Access Compliance Report

Public Rights-of-Way

(Curb Ramps)

Intersection ID: 27495	Main Street: BALLANTYNE_COMMONS_PY	Cross Street: NORTH_COMMUNITY_HOUSE_RD	Location: NE
ADA ID: CD55F7E2A3E8	Ramp Type: Perp	Initial Pass/Fail: Fail	Overall Compliance: No
Severity Score: 21.25			
Codes/Mitigation Info/Possible Solution		Field Measurements/Component Compliance

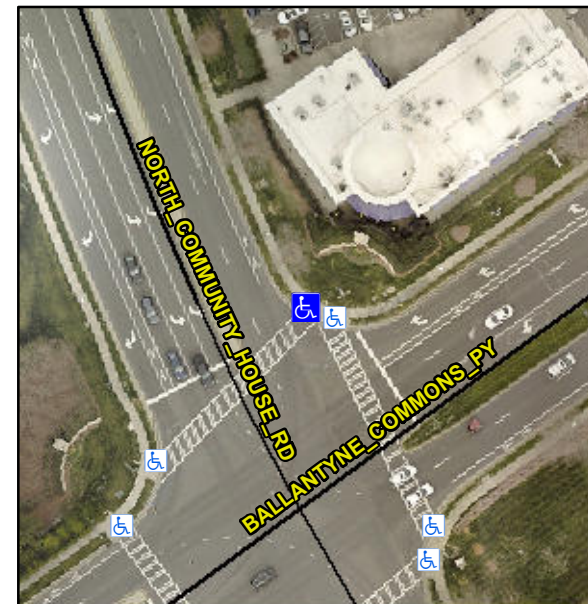
R304.5.1, R304.2.2

Compliance	Description	Data	Compliance	Description	Data
N/A	Ramp Length (in)	47.5	No	Ramp Slope (%)	8.5
No	Ramp Width (in)	46.5	Yes	Ramp XSlope (%)	1.8
N/A	Flare Type LT	N/A	N/A	Flare Type RT	N/A
N/A	Flare Slope LT (%)	N/A	N/A	Flare Slope RT (%)	N/A
N/A	Flare Traversable LT?	N/A	N/A	Flare Traversable RT?	N/A
N/A	Landing Length (in)	N/A	N/A	DWS Provided?	N/A
N/A	Landing Width (in)	N/A	N/A	DWS Contrast?	N/A
N/A	Landing Slope (%)	N/A	N/A	DWS Length (in)	N/A
N/A	Landing X Slope (%)	N/A	N/A	DWS Full Width?	N/A
N/A	Landing Curb? (Y/N)	N/A	N/A	DWS Offset (in)	N/A
N/A	Shared Landing?	N/A			
N/A	Gutter Ponding?	N/A	N/A	Gutter Slope (%)	N/A
N/A	Gutter Lip Ht (in)	N/A	N/A	Gutter X Slope (%)	N/A
N/A	Painted X Walk1?	Yes	N/A	Painted X Walk2?	N/A
	X Walk 1 Direction	To SW		X Walk 2 Direction	N/A
N/A	X Walk 1 Width (in)	125.5	N/A	X Walk 2 Width (in)	N/A
	X Walk 1 Slope (%)	4.4		X Walk 2 Slope (%)	N/A
	X Walk 1 X Slope (%)	0.9		X Walk 2 X Slope (%)	N/A

Remove & Replace Entire Ramp.
